APPLICATION NO.	FILING DATE	FIRST NAMED INVENTOR	ATTORNEY DOCKET NO.	CONFIRMATION NO.
10/590,335	05/12/2008	Howard Lee Loewenthal	ANDP101US	8371
96218	7590	03/07/2012		
Sprigel and Associates 110 West Streetsboro Street L4 and L14 Hudson, OH 44236			EXAMINER SIMMS JR, JOHN ELLIOTT	
			ART UNIT	PAPER NUMBER
			3711	
			MAIL DATE	DELIVERY MODE
			03/07/2012 PAPER

Office Action Summary**Application No.**

DETAILED ACTION

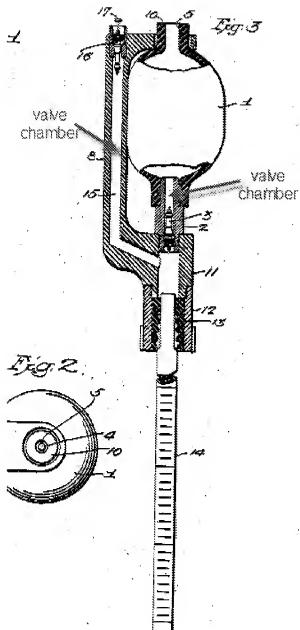
5. As to Claim 2, Caulfield teaches no second valve assembly, see Figure 1, and a valve assembly outer diameter configured to create an interference fit with the inside diameter of a boss (11) on the tube first opening, see Figure 1. Caulfield, as modified, teaches the claimed invention, except for interposing the boss between the valve assembly and the tube first end. It would have been an obvious matter of design choice to form the boss integral with the tube first end, since the applicant has not disclosed that a one-piece design solves any stated problem or is for any particular purpose and it appears that the invention would perform equally well with the boss. As to Claims 3 and 13, Caulfield teaches a device having a first axis parallel to a long axis of a tube (14), when the tube is in a vertical position, see Figure 1, and a second axis at ninety degrees and perpendicular to the first axis, see Figure 1. The examiner notes that the device of Caulfield is capable of being turned to approximately less than ninety degrees without leaking fluid. With particular regard to Claim 13, Caulfield does not show a second valve assembly. As to Claim 4, Caulfield teaches an alternative embodiment of a device having a valve assembly (2, 3, 8, 11, 16), page 1, Col. 1, ln. 50-53, and see Figure 3, and including a first valve chamber with a first opening, in the first valve chamber, and a second valve chamber with a second opening, in the second valve chamber, that operate in opposing directions, page 2, Col. 1, ln. 43-60, and see Figure 3, reproduced below. The examiner notes that to fill the tube (14) expanding air will flow in a first

direction through a first opening or a second opening and expelled air from the bulb (1), to empty fluid will flow in a second direction opposite of the first opening or the opposite of the second opening, page 2, Col. 1, ln. 75 - Col. 2, ln. 4. It would have been obvious to one of ordinary skill in the art, at the time of the invention, to provide Caulfield with the features exhibited in Figure 3, as suggested, to provide first and second chambers with first and second openings, as suggested, to incorporate a valve assembly having first and second valve chambers. Caulfield, as modified, teaches the claimed invention, except for showing the outer surface of the tube (14) forming a seal with the inner surface of the valve assembly, instead of the outer surface of the valve assembly forming a seal with the inner surface of the tube. It would have been an obvious matter of design choice to reverse the male and female aspects of the valve assembly and tube since applicant has not disclosed that the specific choice of fitting the valve assembly into the tube solves any stated problem or is for any particular purpose and it appears that the invention would perform equally well with the tube fitting into the valve assembly, as taught by Caulfield. As to Claim 9, Caulfield teaches a manually closeable vent hole (5), page 2, Col. 1, ln. 1-5. As to Claim 10, Caulfield teaches an elastomeric bulb (1) having a weighted portion of its surface (8), see Figure 1. The examiner notes that the weighted portion would cause the device to rest on the weighted portion (8), when placed on its side. As to Claim 12, Caulfield teaches a leak resistant siphoning device including an elongated hollow tube (14), having a first opening at a first end, a second opening at a second end and an elongated body region between the first end and the second end, and a valve assembly (2, 8, 11), page 1, Col. 1, ln. 50-53, and see Figure 3. Caulfield teaches a second end of the tube having an interior comprising a tapered tubular

surface and a bulb (1), at the second end second opening, see Figure 3. The examiner notes that the valve assembly (2, 8, 11) is configured for connection to the second opening of the second end and the outer diameter of the valve assembly (2, 8, 11) forms a non-fixed seal with the inner diameter of the second end of the tube (14), page 1, Col. 2, ln. 36-37.

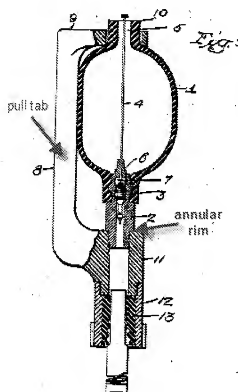
to the inclusion of plastic, silicone, and a polymer. Porter teaches a baster (100) formed using rubber, silicone, or other polymeric materials, Col. 4, ln. 36-37. It would have been obvious to one of ordinary skill in the art, at the time of the invention, to provide Caulfield, as modified, with a valve assembly formed of an elastomer, silicone, and a polymer, as taught by Porter, to provide Caulfield, as modified, with a valve assembly formed of multiple materials, as taught by Porter, to provide Caulfield with a valve assembly formed of specifically selected materials to yield the predictable result of providing a suitable structure at a minimum cost. Caulfield, as modified, teaches the claimed invention, except for indicating the use of plastic, in the valve assembly. Suter teaches a juice extractor (50) having a valve assembly formed of plastic, Col. 11, ln. 40-42. It would have been obvious to one of ordinary skill in the art, at the time of the invention, to incorporate plastic material into the valve assembly, as taught by Suter, to provide Caulfield, as modified, with an additional material forming the valve assembly, to yield the predictable result of providing a valve assembly incorporating the most advantageous composition. With particular regard to Claim 14, Porter teaches a valve assembly excluding metals. It would have been obvious to one of ordinary skill in the art, at the time of the invention, to provide Caulfield, as modified, with a valve assembly having no metals, as taught by Porter, to provide Caulfield, as modified, with a non-metal construction, to yield the predictable result of reducing costs. As to Claim 6, Caulfield teaches a single valve opening/slit in the valve assembly, see Figure 1, the valve assembly having an annular rim, which limits insertion of the valve assembly into a boss (11) which forms a seal with the tube (14) and a pull tab (8) configured to allow the valve assembly to be removed from the tube (14), see reproduced Figure 1, below. Caulfield, as modified, teaches the claimed invention, except for teaching the

valve assembly being inserted into the boss, which is sealed with the tube instead of showing the valve assembly inserted directly into the tube. It would have been obvious to one having ordinary skill in the art at the time the invention was made to construct the boss to be integral with the valve assembly, since it has been held that use of one piece construction instead of rigidly secured parts is an obvious matter of engineering choice, *In re Larson*, 340 F. 2d 965, 968, 144 USPQ 347, 349 (CCPA 1965).
